Pima County Regional
FLOOD CONTROL
DISTRICT

Re: Pima County Regional Flood Control District
Review of Preliminary FIS and FIRM data

The Pima County Regional Flood Control District (District) has reviewed the Preliminary Flood Insurance Study (FIS), Flood Insurance Rate Maps (FIRMs) and associated digital data. Our review was directed primarily towards the unincorporated areas of Pima County. The following comments are provided:

Figure 1 - The Preliminary Base Flood Elevations are in blue.
The existing regulatory Base Flood Elevations are in red.

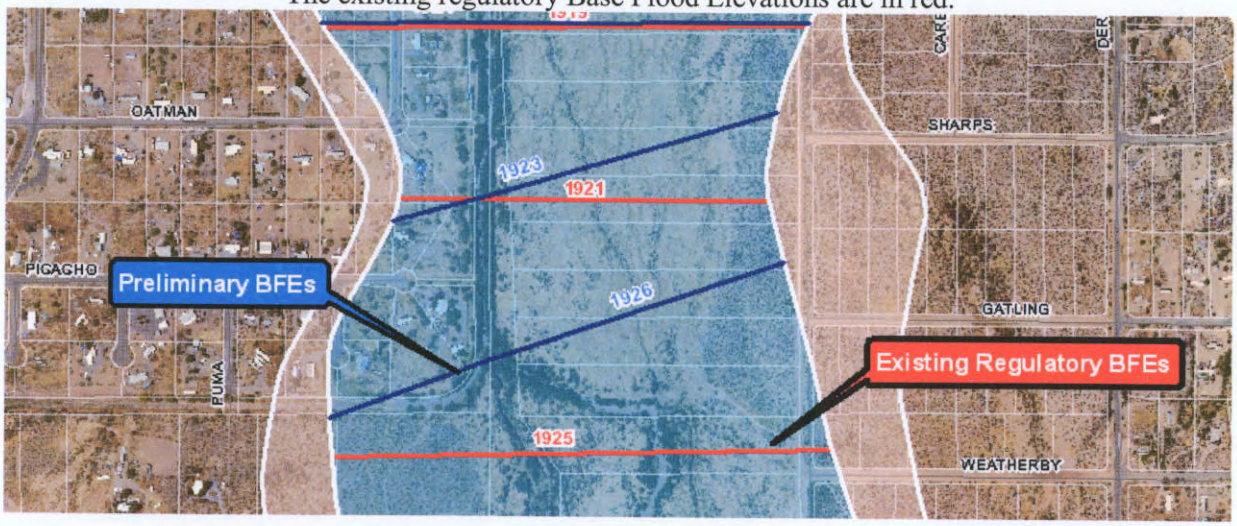
1. In sections 21, 21, 28 and 29, the alignment of the water surface elevations has changed dramatically (see Figure 1 below). Please justify this realignment or have the new BFE lines parallel the existing FIRM data. If FEMA developed a new hydraulic model to reorient and modify the base flood elevations, The District would need a copy of that model for floodplain management purposes.

Figure 2 – Floodplain boundary does not reflect topography

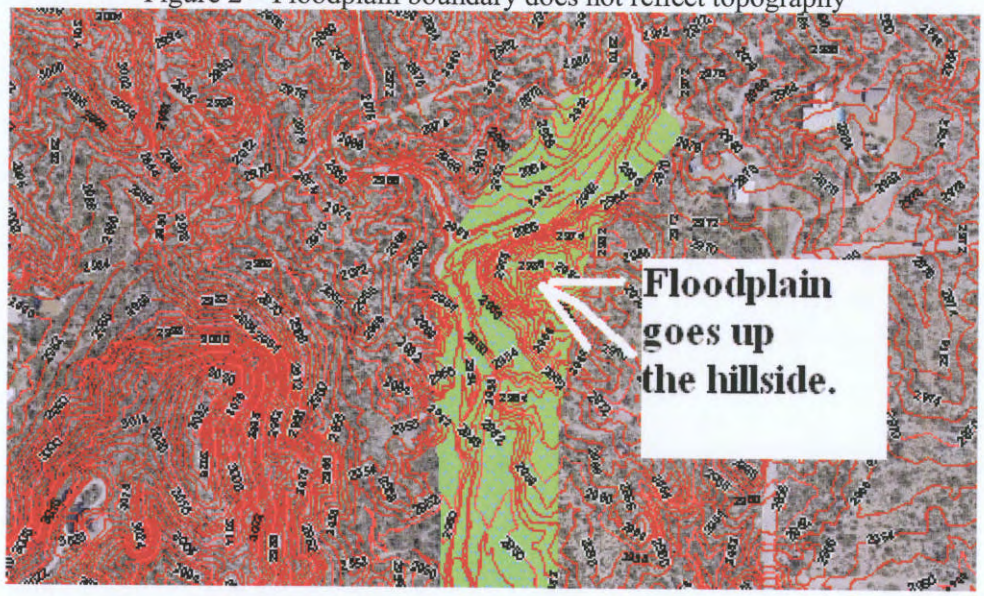
1. In section 21 the floodplain climbs up a hill. See Figure 2 below.

Figure 3 – Remove the levee label at the base of the hill.

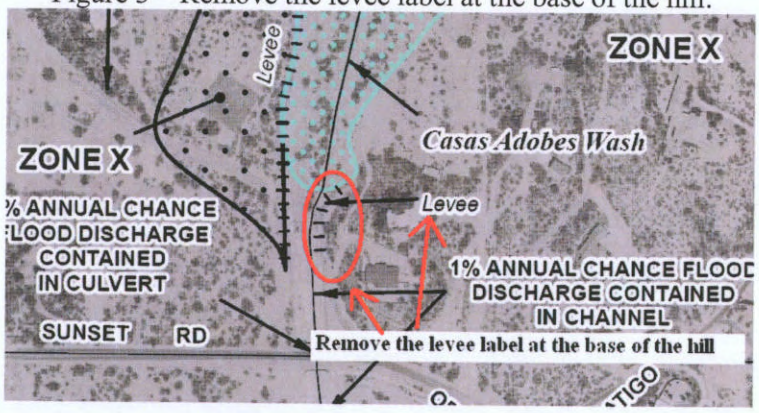
1. The levee shown on southeastern corner of A Zone in Section 10 is not a levee. It is along the base of a hill. During the Provision Accreditation of Levee process, the District requested the levee designation be removed from this location. See Figure 3 below.

Figure – 4 – The A-zone floodplain does not fit in detention basin.

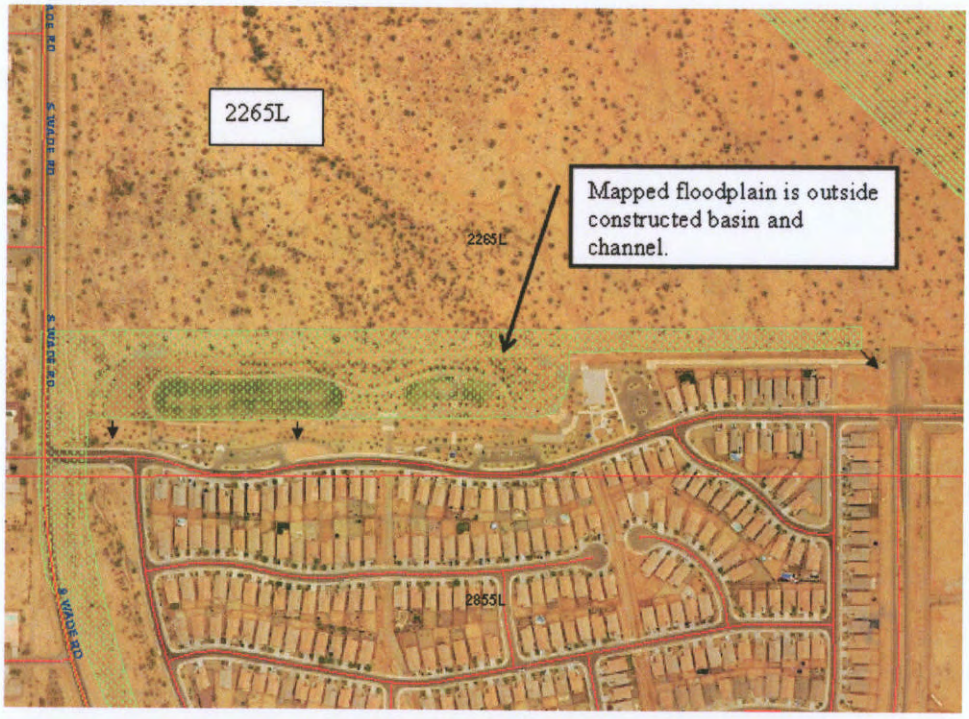
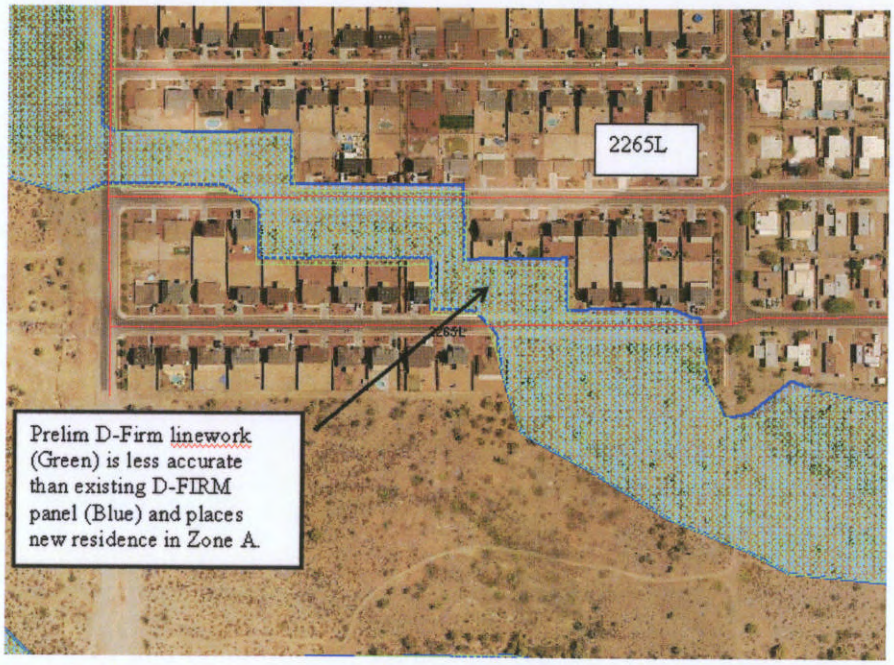
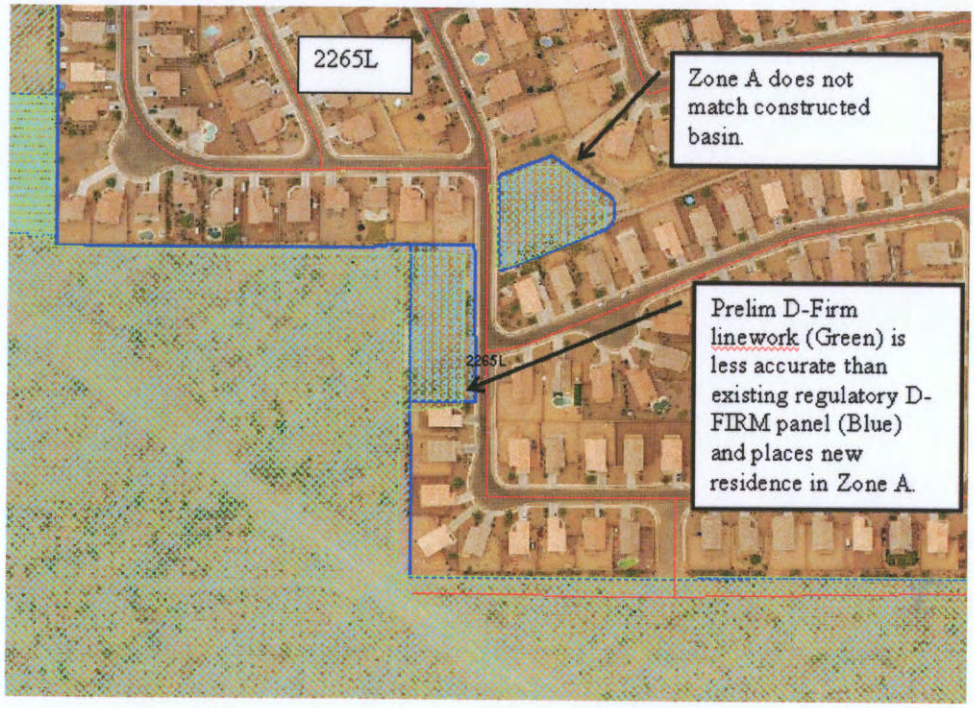
1. In several areas the existing regulatory floodplain data is more accurate than the Preliminary D-FIRMs. See Figures 4, 5 and 6. Corrected Shape files are contained in the attached CD.

Figure – 7 – The Preliminary D-FIRM data is shifted to the west.

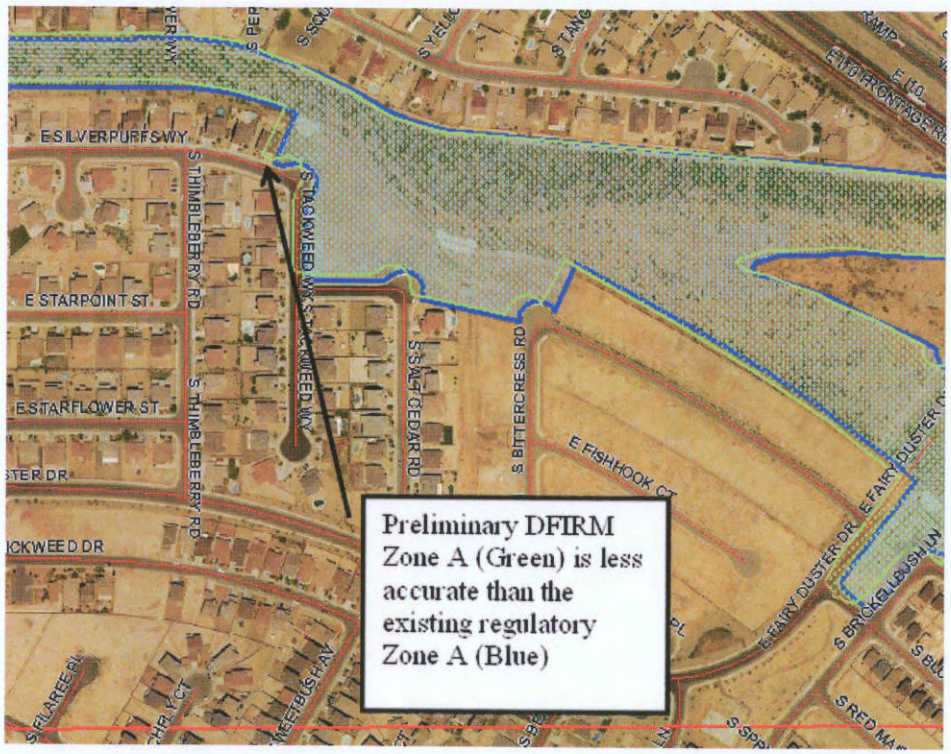
1. The Preliminary Zone A floodplain in the southern portion of panel 2295L has slipped west of the existing regulatory data. See Figure 7. Corrective shape files are contained in the attached CD.

Figure – 8 – The floodplain limits shifted on the Preliminary D-FIRM Data

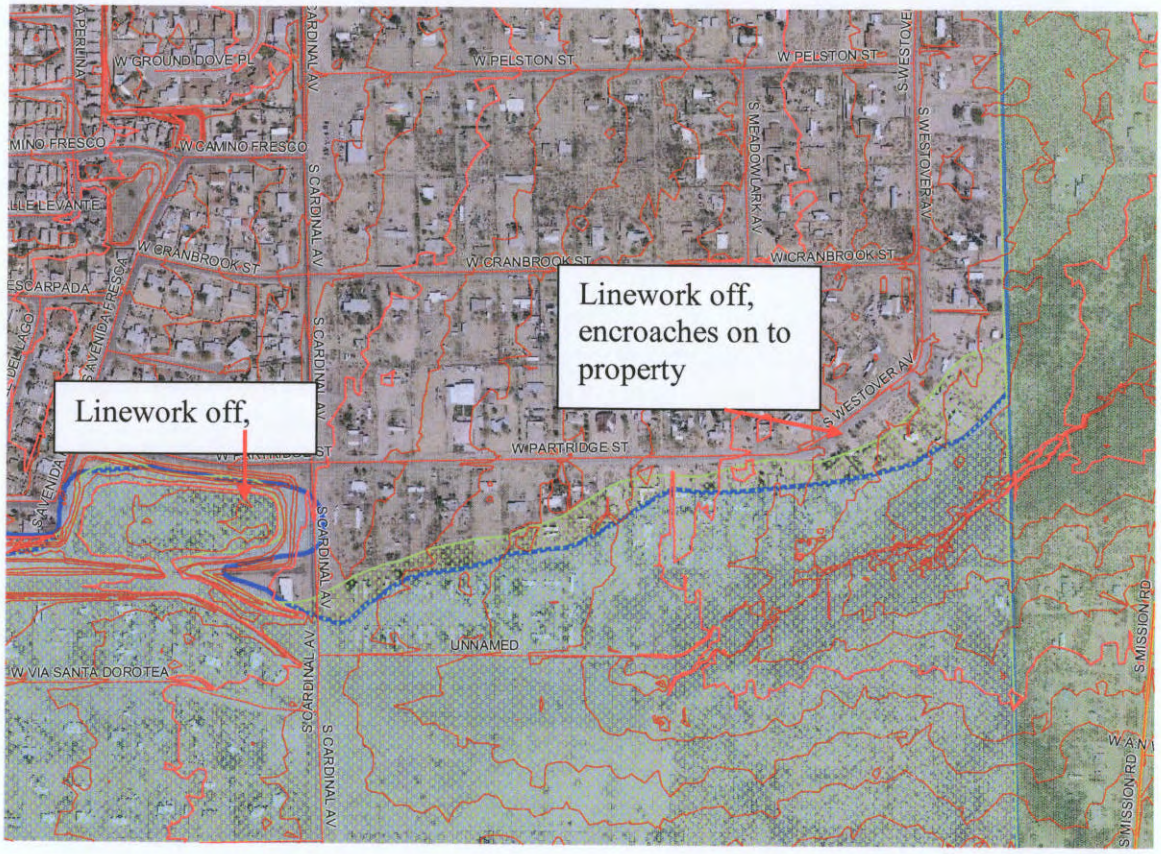
1. The A-Zones have been extended north past the existing regulatory limits and do not fit the upstream detention basin. See Figure 8 Corrective Shape files for this A-Zone were prepared to match the previous A-zone limits and improve detention basin limits and are included in the attached CD.

Figure – 9 – The floodwall line work encroaches onto residential structures.

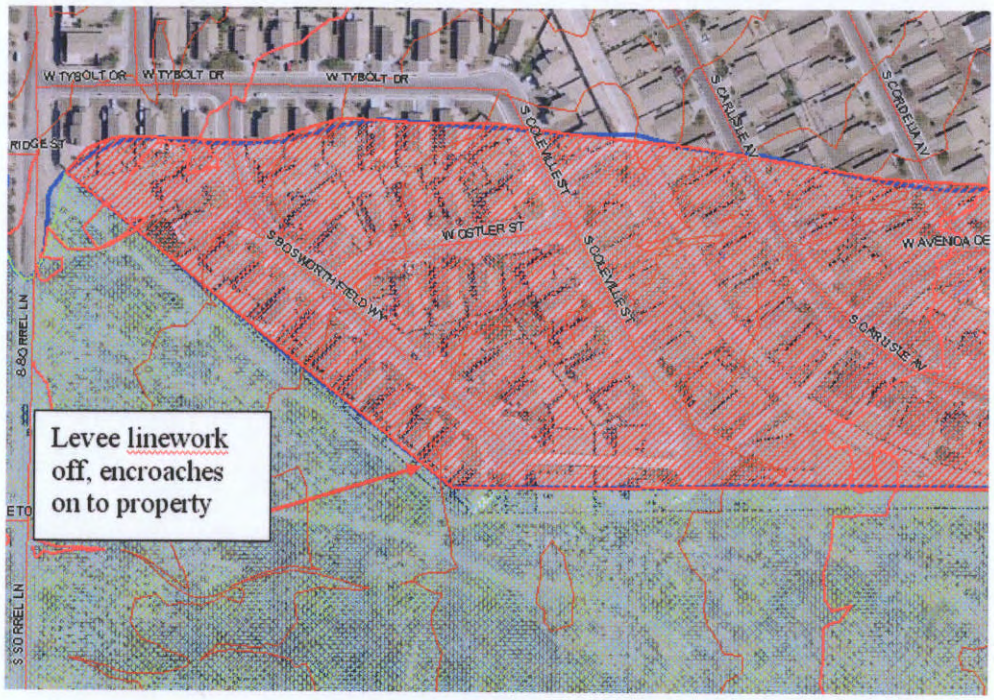
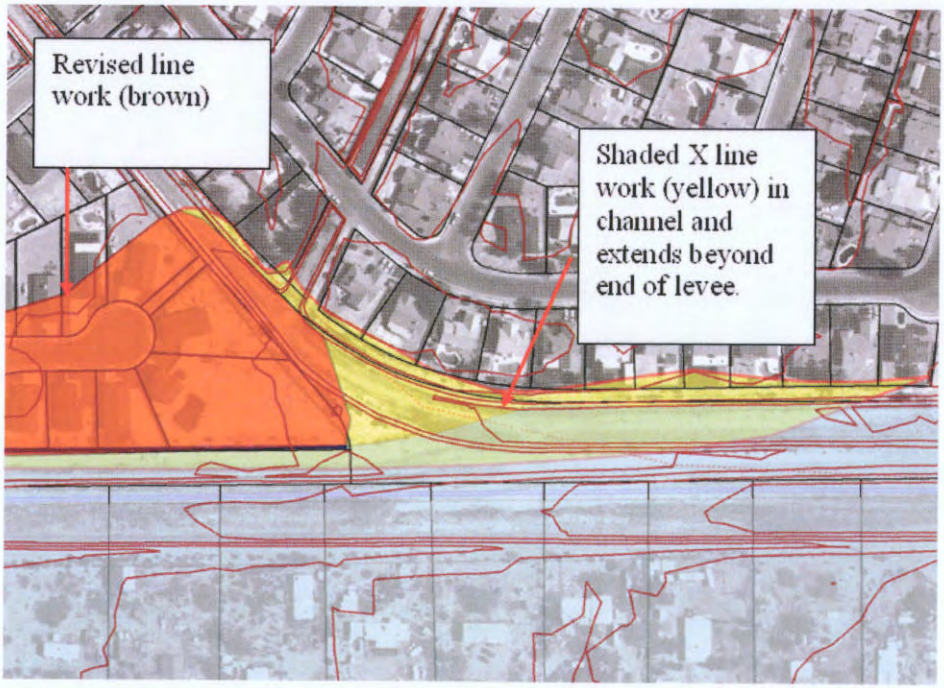
2. The Levee line work for the Mission West Floodwall places structures in floodplain. Figure 9 show the levee location crosses residential structures. An ESRI Line file was prepared for the levee. Shape files for the A-Zone and Shaded X were also generated and are on the attached CD. Figure 10 shows the corrected locations of the flood zones.

Figure – 11 – The floodplain limits shifted on the Preliminary D-FIRM Data

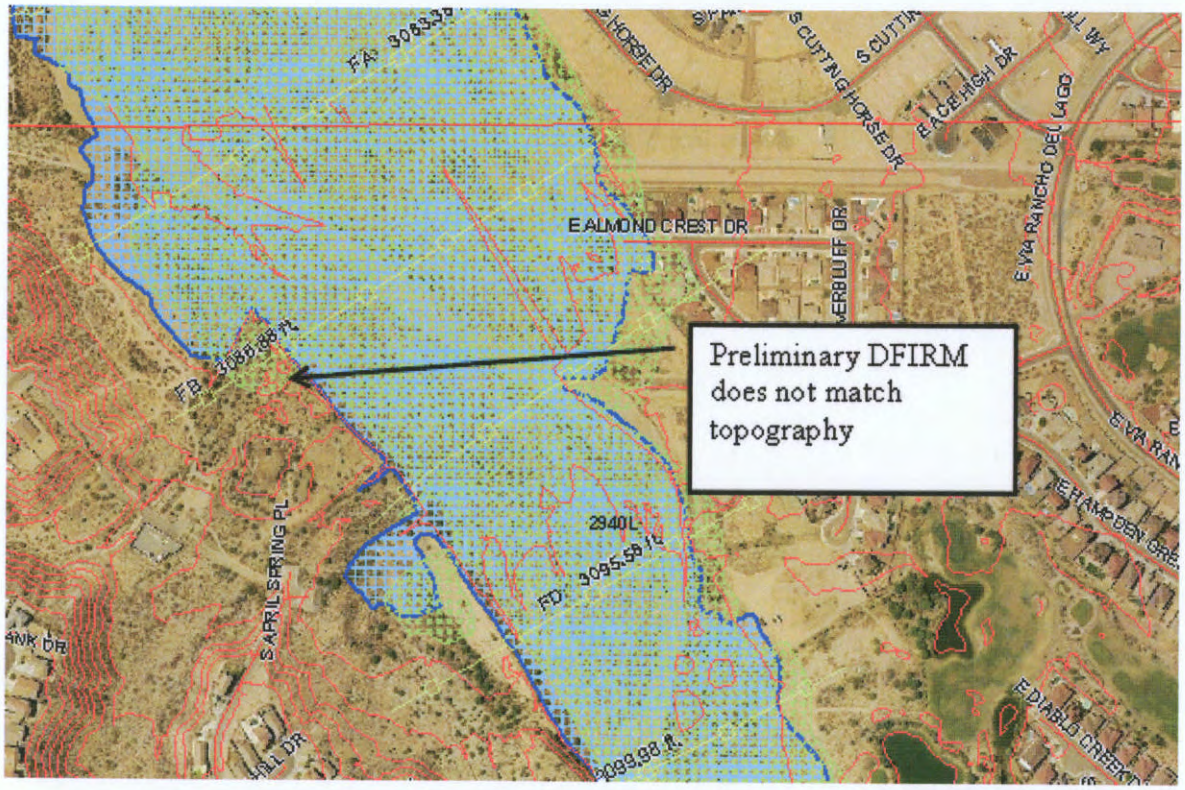
1. The Preliminary FIRM floodplain and floodway boundaries for the Pantano Wash are offset from actual topographic conditions south of Vail Ranch Road within Sections 4, 9, and 10 T16S R16E, on panels 2930L and 2940L. See Figure 11. Shape files of existing regulatory floodplain and floodway are included in the attached CD and should replace the Preliminary data between Cross Sections ES and FO.

Figure – 12 – Erosion has occurred on the Pantano Wash outside the mapped floodplain.

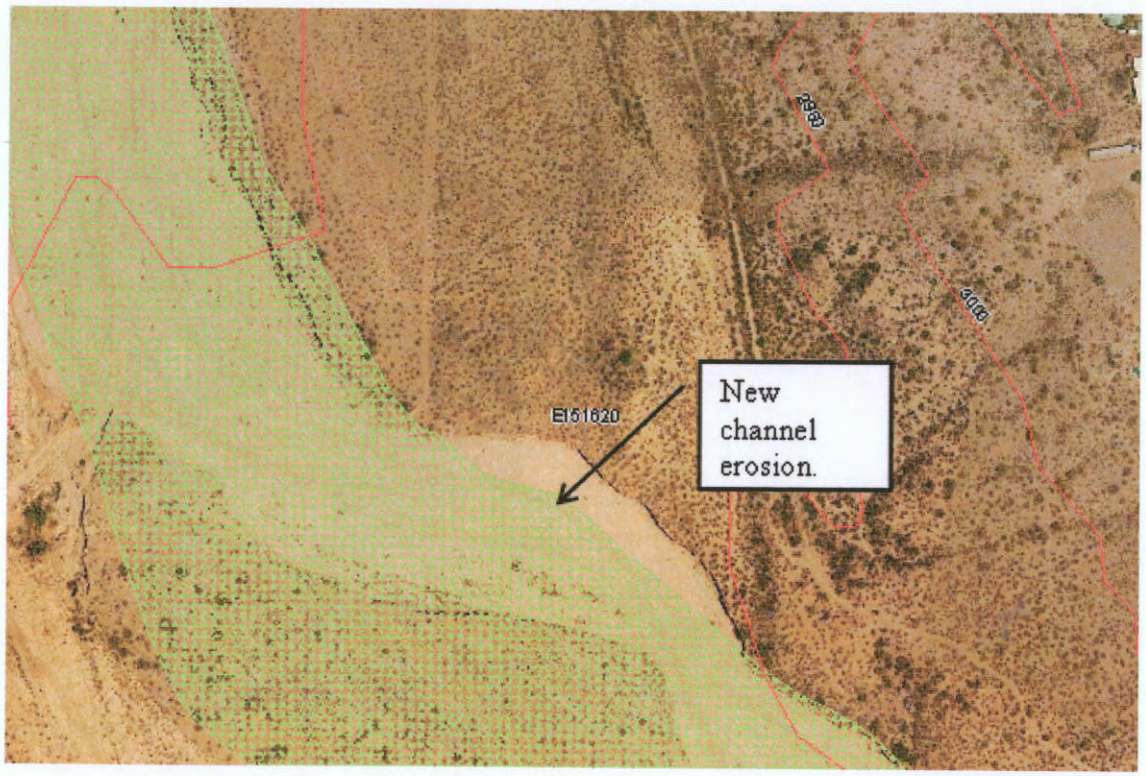
2. The July 31, 2006, flood on the Pantano Wash caused the channel to meander outside of the mapped floodplain. See Figure 12. In some locations the channel has moved laterally over 100-feet in some areas within panel 2930L. These newly eroded meanders have been digitized and included as an unnumbered Zone A on the attached CD. New meander erosion occurs along cross sections DT, between DU and DV, and along cross section EA in Sections 20 and 29.

Figure – 13 – Downstream cross section should not have a higher water surface elevation.

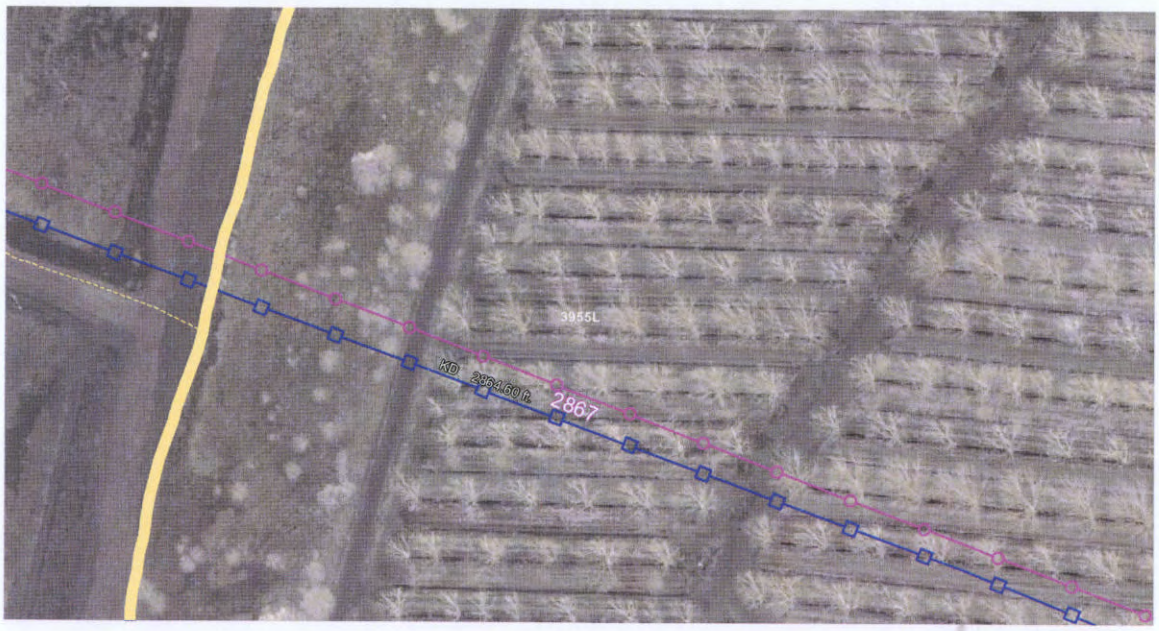
1. Forty feet downstream on cross-section KD the WSE is 2867. Cross Section KD has a WSE 2864.60'. There seems to be a bust between BFE and the Cross Section data in the attribute table. See Figure 13.

Figure – 15 – Preliminary Floodplain has extended up the slope of a hill.

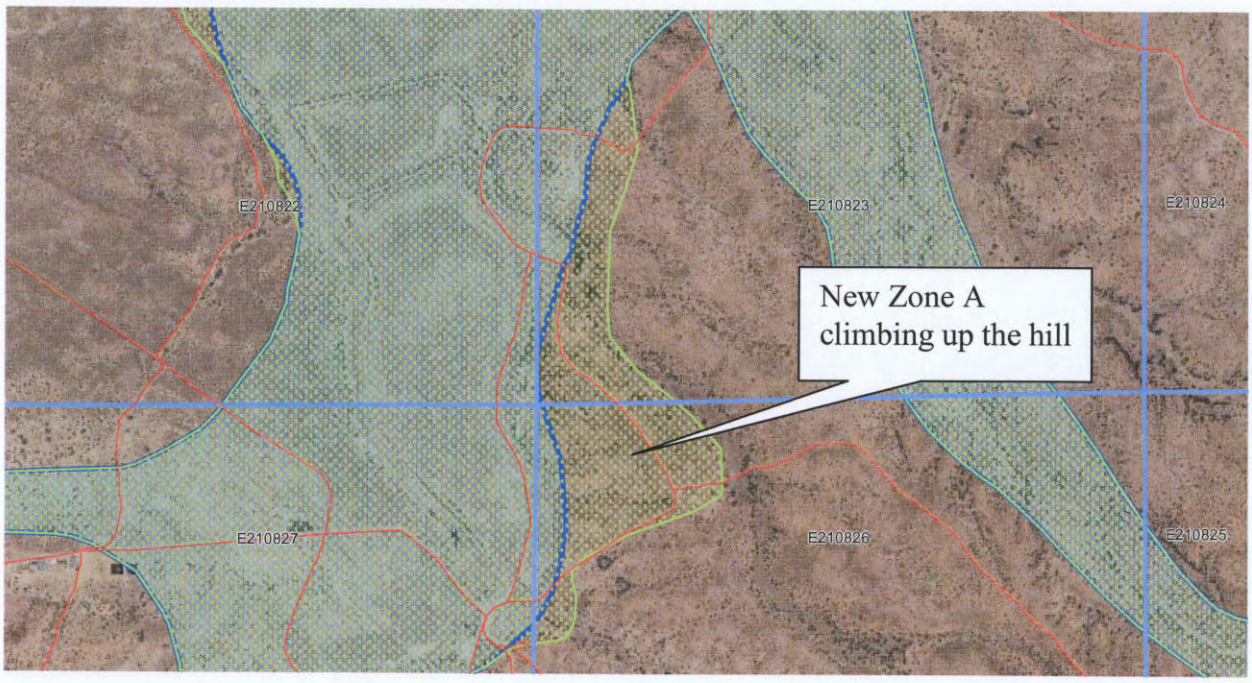
1. In Section 23 and 28 a new Zone A is climbing up the hill. See Figure 15 for location.
